SSD- 69683218  
Shoalhaven City Council Response to Request for Comments

I refer to the Department of Planning, Housing, and Infrastructure's request for comment in relation to the proposed mixed use development with in-fill affordable housing over property Lots 8 to 10 DP 1291324 at 1, 7 & 15 Saltmarsh Rise, St Georges Basin.

#### Ground floor plan of Dwelling A1-1

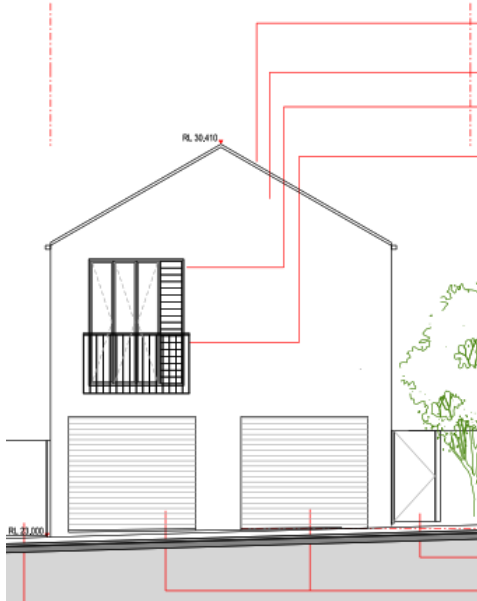
The dwellings are shown with a potential washing machine location (marked W). Part 10.4.1 of the ABCB Housing Provisions (HP) requires clothes washing facilities to consist of a washtub and a space for a washing machine. The proposed washing machine locations do not appear to have the potential to comply with the space for a washtub and amendments to the floor plan may be required.

This could be detailed at CC stage, and if required by the certifier, a modification to the DA submitted if considered inconsistent with any approval.

Dwg A1-06 – Guttering shown to encroach over proposed strata boundary

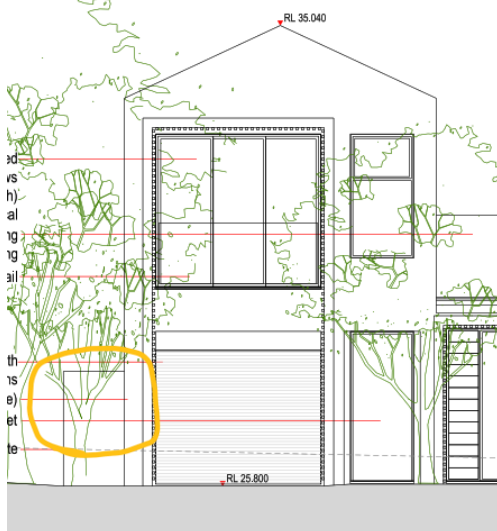
The guttering of the dwellings and garage on many of the proposed allotments encroach over a strata boundary.

All buildings should be wholly contained within their subject allotment (strata or Torrens titled) to comply with the BCA. *Standards Australia HB50 Glossary of building terms* defines a boundary as the “limit or extent of a site under a single occupancy, whether fenced or unfenced”. A strata boundary is not considered any differently to that of a Torrens title boundary.

The roofline of the buildings may need to be reconsidered/ re-design to ensure that the buildings are contained wholly within their allotments. The applicant may wish to increase the setback of the detached garages from the boundary to contain the buildings wholly within their allotment.

From Dwg C2-08 – highlighted - excavation shown across common boundary with Park

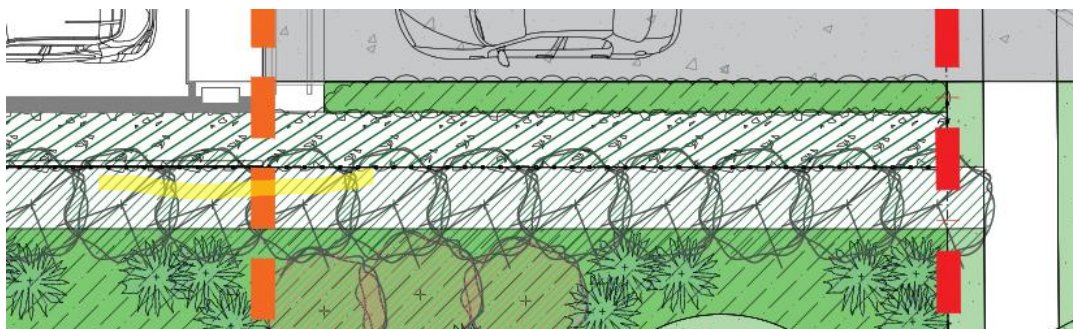
The front/ eastern elevations of the dwelling in Precinct C2 appear to show proposed cut/ excavation to create relatively level front setbacks. Please refer to the snip from Drawing C2-08 below. The plans do not show the point/ start of excavation and appear to show the excavation commencing in the proposed park between Precincts C and D.

The landscaping plans (Appendix Y) do not show any excavation to create the Park. A retaining wall is shown for the fill along the southern boundary of Precinct C, but no retaining is shown in the front setback of the dwellings in the Precinct.

The plans for Precinct D do not appear to show any cut extending across the Park. The existing and finished ground levels, and the extent of any earthworks, for Precincts C and D and the Park, should be determined and represented on plan for consideration.

From Dwg EMP009 showing Precinct E AS2890.6 accessible parking spaces

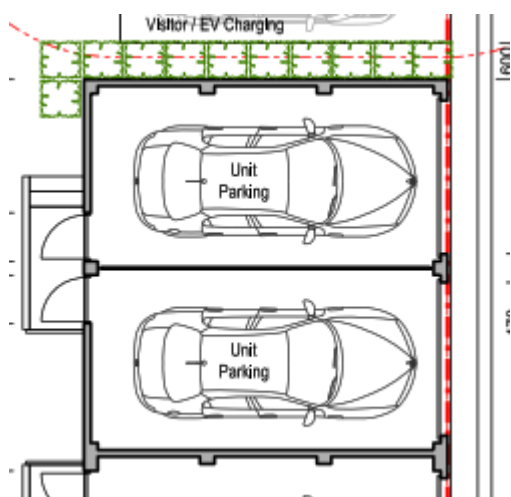
The Access Report, in the adaptability section (p.50) indicates that parking spaces are being provided in accordance with AS2890.6. There are only three (3) accessible spaces complying with AS2890.6 shown on plan, on or near this Precinct.

Parking for the adaptable sole occupancy units should be clarified and demonstrate that compliance can be achieved.

Dwg EMP011 showing lightweight construction between parking spaces.

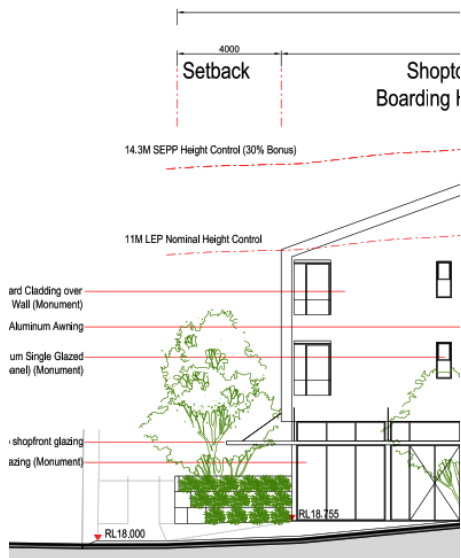
The only other potential parking spaces that could be used are some of the garages in the eastern building in the Precinct where it appears lightweight construction separates two spaces. Potentially the internal frame wall could be removed to create one large space. However, each one of these garages requires an occupant to use the door in the western elevation to access their dwelling and all show step/s which does not appear to make this option practical or compliant with the objectives of AS4299.

Dwg EMP020

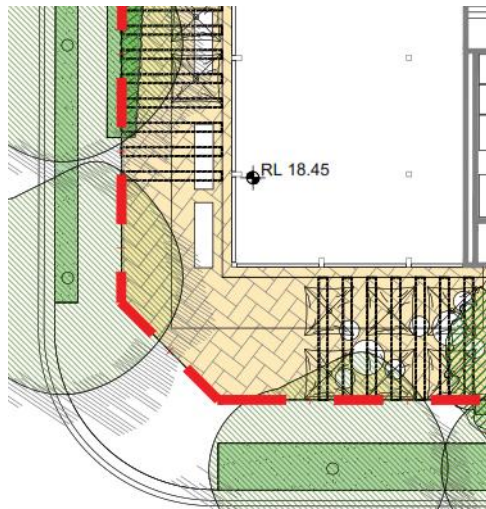
- Commercial - There is insufficient and contradictory information provided which prevents a determination on whether access for people with a disability can be provided. The landscaping plan shows a FL of 18.45 mm, and the southern architectural elevation shows the floor level to be 755 mm above the footpath level (on fill) (RL18.755) with the building setback 4 metres. The floor plan of the commercial space clearly shows this corner as being step free and therefore the principal pedestrian entry is likely in this area. The gradients of these potential accessways to the commercial premises are approximately 1:9 and 1:5 respectively which are too steep for ramps or accessways.

Clarification of levels should be requested, and it should be demonstrated that accessibility is capable of being achieved.
